Ginna Station

UFSAR Section 6.2.4 and Tables 6.2-13, 6.2-14 and 6.2-15 Changes

NSL-0000-SA024

Revision 3

Figure 6.2-37
Component Cooling Water to Reactor
Coolant Pump 1A, Penetration No. 127

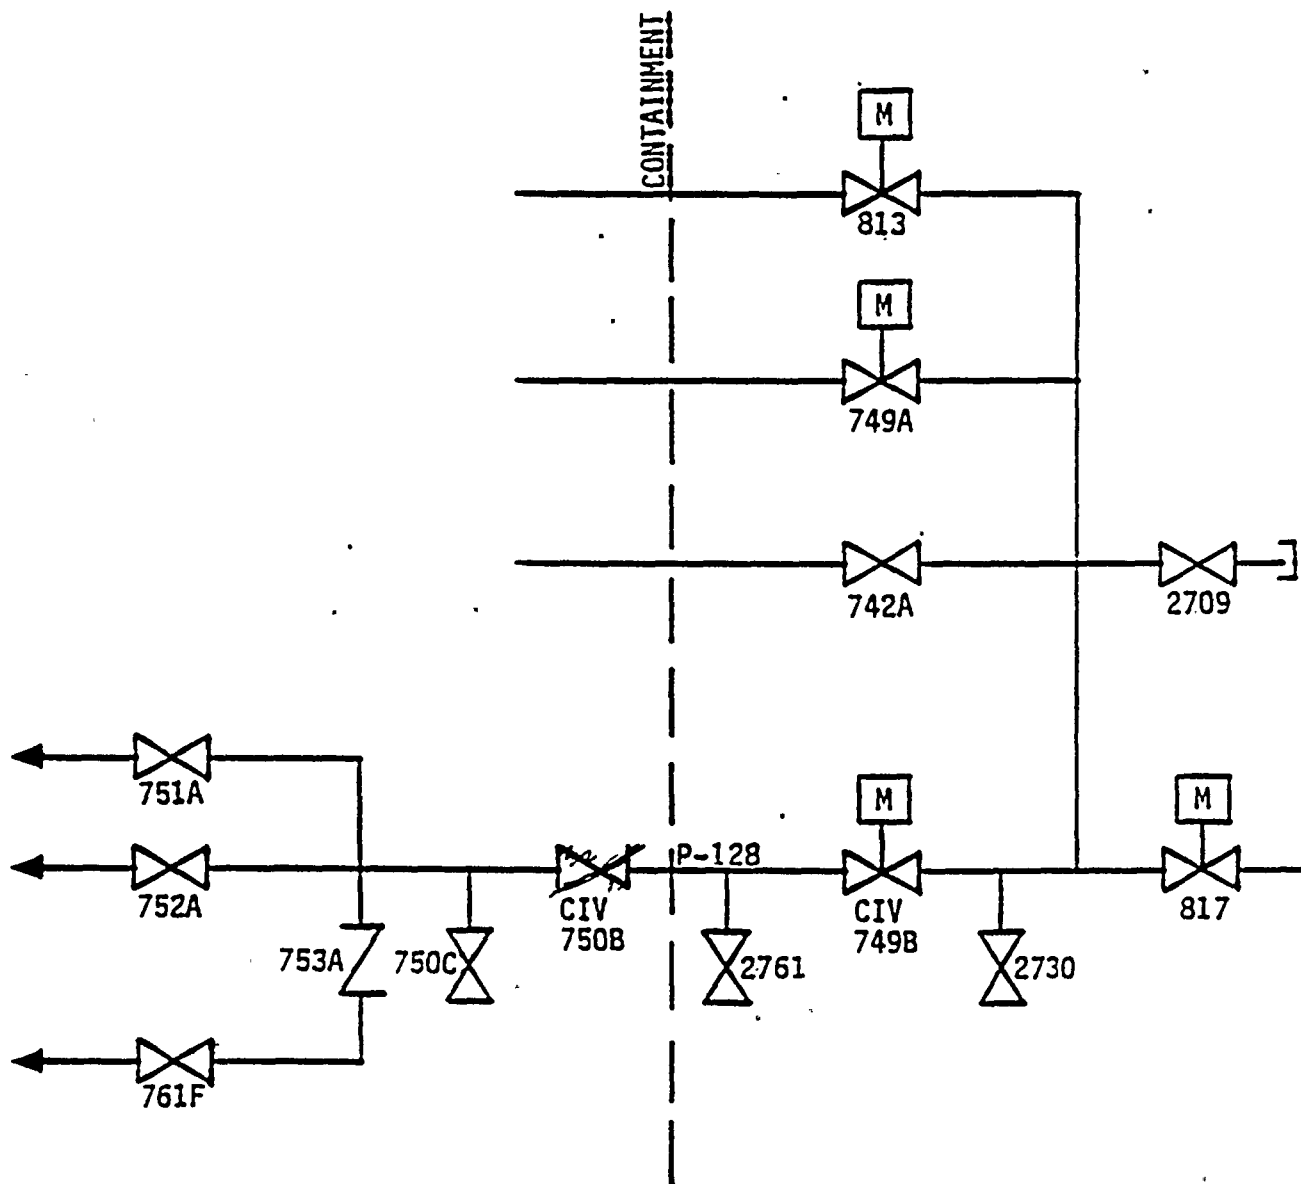
30.	Penetration 127 - (1) Changed <u>Position Indication In Control Room</u> from "Yes" to "R/B" for valve 749A; (2) Changed <u>Position At Cold Shutdown</u> from "O" to "C" for valve 749A; (3) Global Notes 1, 2, and 4 for valve 750A; (4) Changed <u>Maximum Isolation Time</u> from "60" to "NA" for valve 749A.	(1) Minor clarification only. No technical change. (2) Update for better representation of system configuration since RCPs are not operating during cold shutdown conditions. (3) No technical change. (4) Correction of typographical error. No technical change.

Figure 6.2-38
Component Cooling Water to Reactor
Coolant Pump 1B, Penetration No. 128

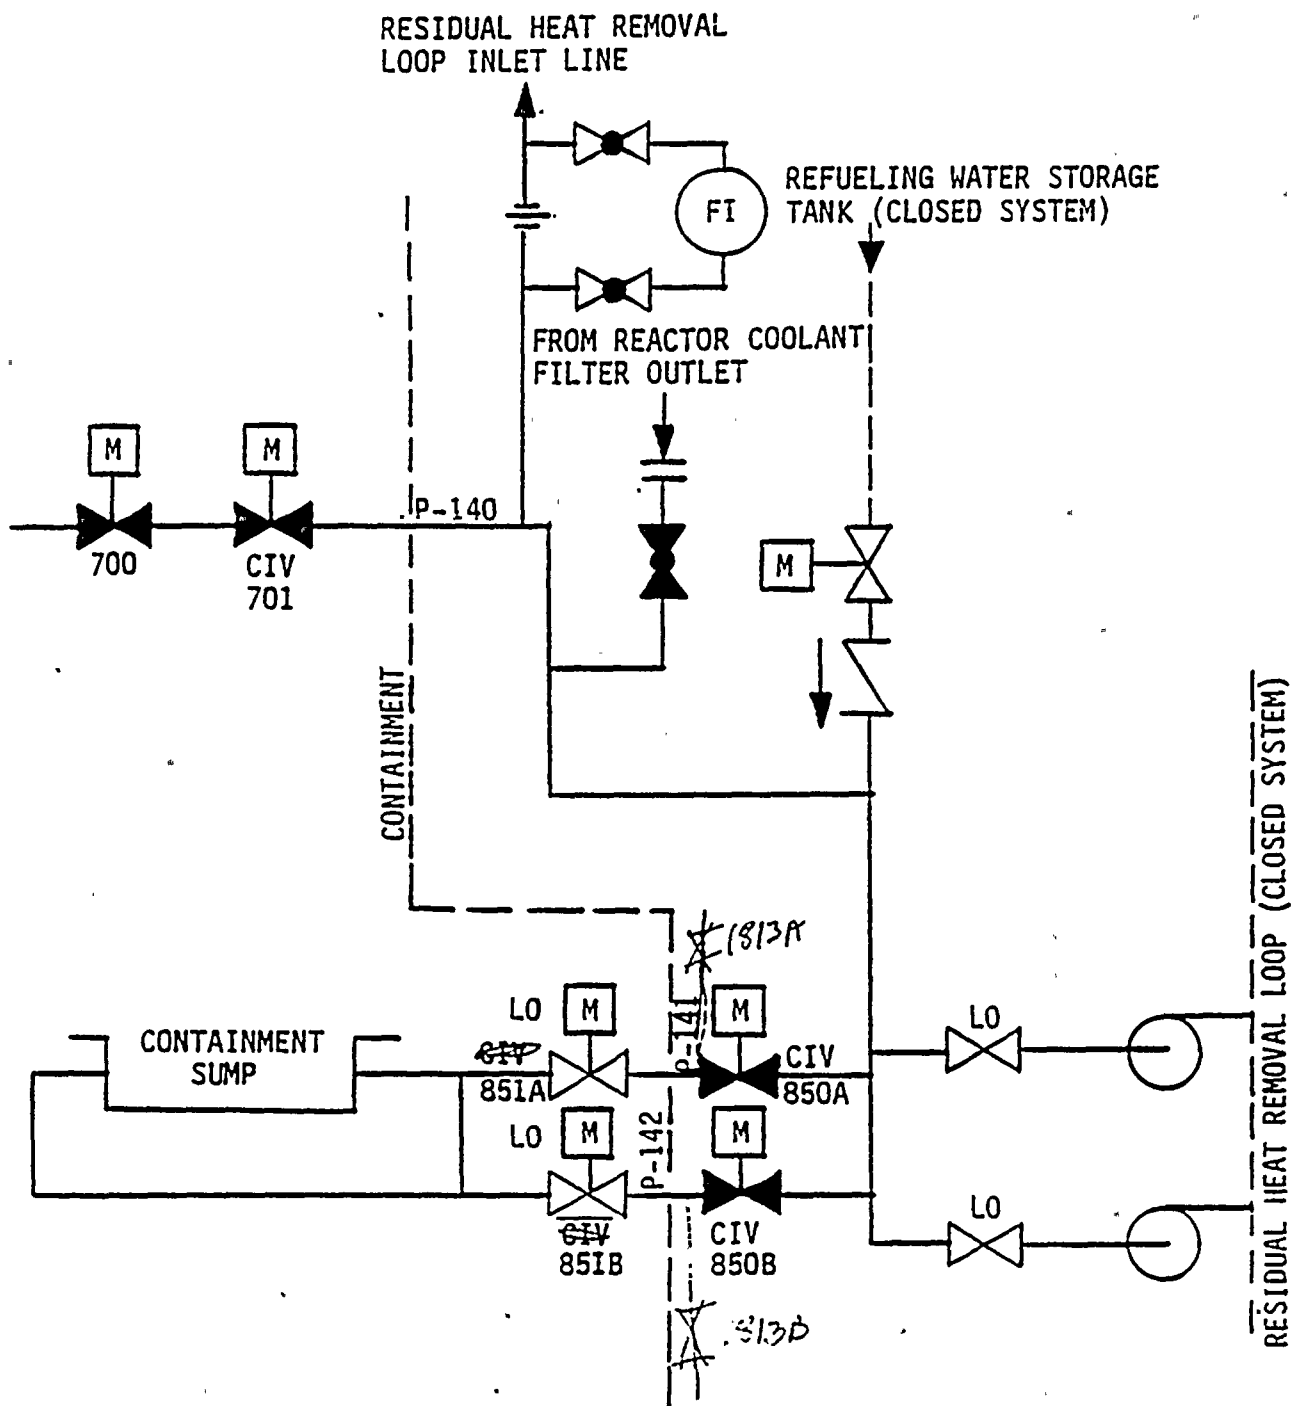
31.	Penetration 128 - (1) Changed <u>Position Indication In Control Room</u> from "Yes" to "R/B" for valve 749B; (2) Changed <u>Position At Cold Shutdown</u> from "O" to "C" for valve 749B; (3) Global Notes 1, 2, and 4 for valve 750B; (4) Changed <u>Maximum Isolation Time</u> from "60" to "NA" for valve 749B.	(1) Minor clarification only. No technical change. (2) Update for better representation of system configuration since RCPs are not operating during cold shutdown conditions. (3) No technical change. (4) Correction of typographical error. No technical change.

Figure 6.2-42

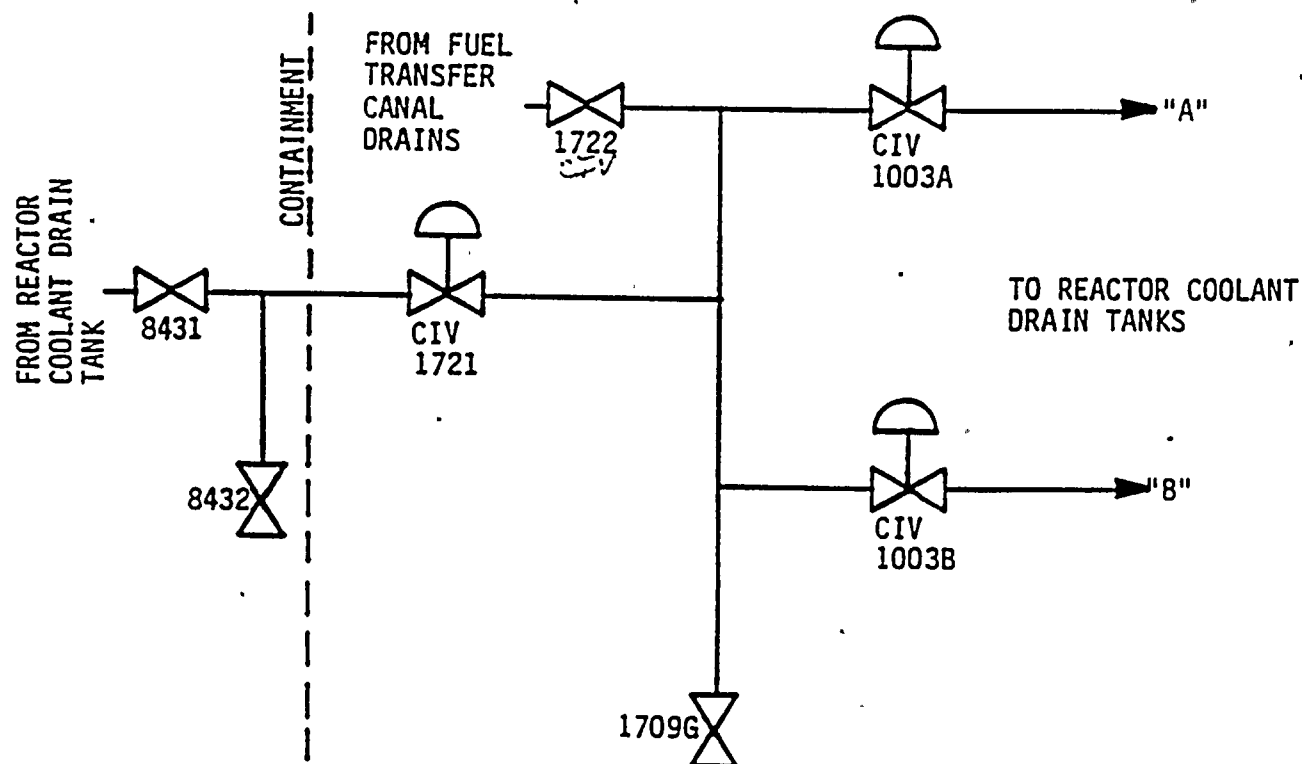
- (d) 123 (bottom) - Added valve 1600A. See explanation for 3.3.2.7 (b) above.
- (e) Penetration 141 - Deleted valve 851A and added valve 1813A. Valve 851A does not meet the selection criteria for 10CFR50 Appendix J, Section IIH, items 1 through 4. Consequently, the valve was deleted from the table. Valve 1813A was previously missing from the table. This valve is locked-closed with its breaker locked open.

- (f) Penetration 142 - Deleted valve 851B and added valve 1813B. See explanation for 3.3.2.7 (e) above.
- (g) Penetration 205 - Added valve 955. See explanation for 3.3.2.7 (b) above.

3.4.1 Section 6.2.4.4.2.2 - The discussion concerning line 140 was revised to show that only one motor-operated valve is provided for this penetration instead of the two previously listed. There are in-fact two motor-operated valves in this line; however, credit is only taken for one of these valves as an isolation barrier (see UFSAR Table 6.2-13 and Reference 2.7). Consequently, the discussion was modified to reflect only a single valve.

Figure 6.2-55

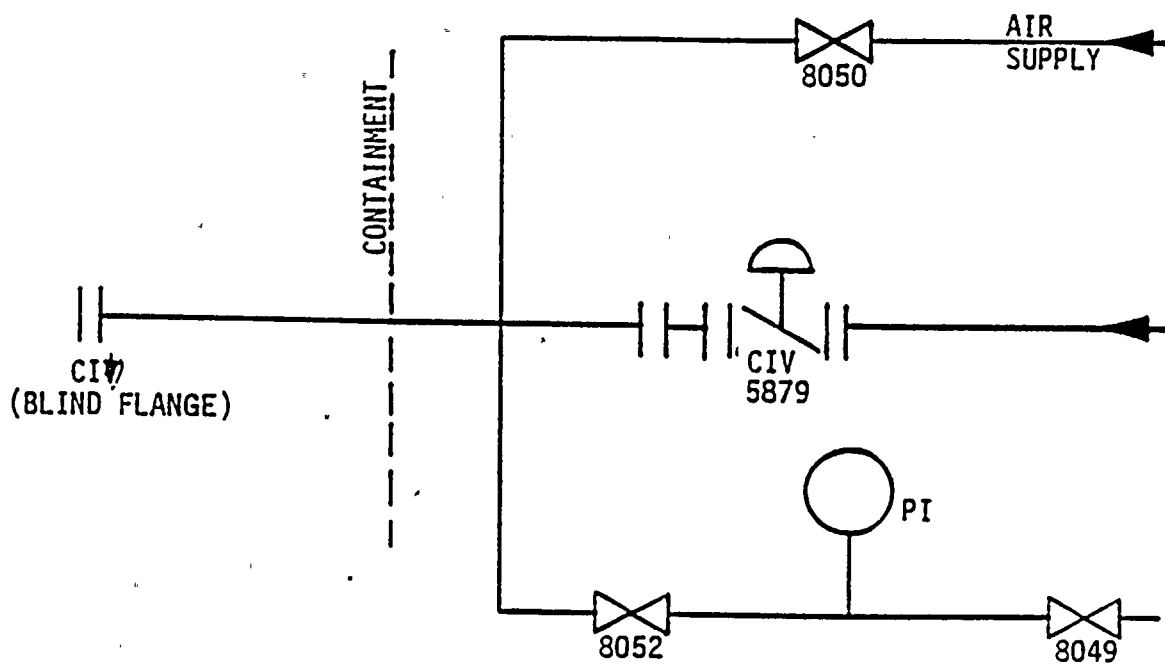
- (j) Penetration 210 - Added valves 10214S1 and 10215S1. These valves were previously missing from the table, but receive an isolation signal.
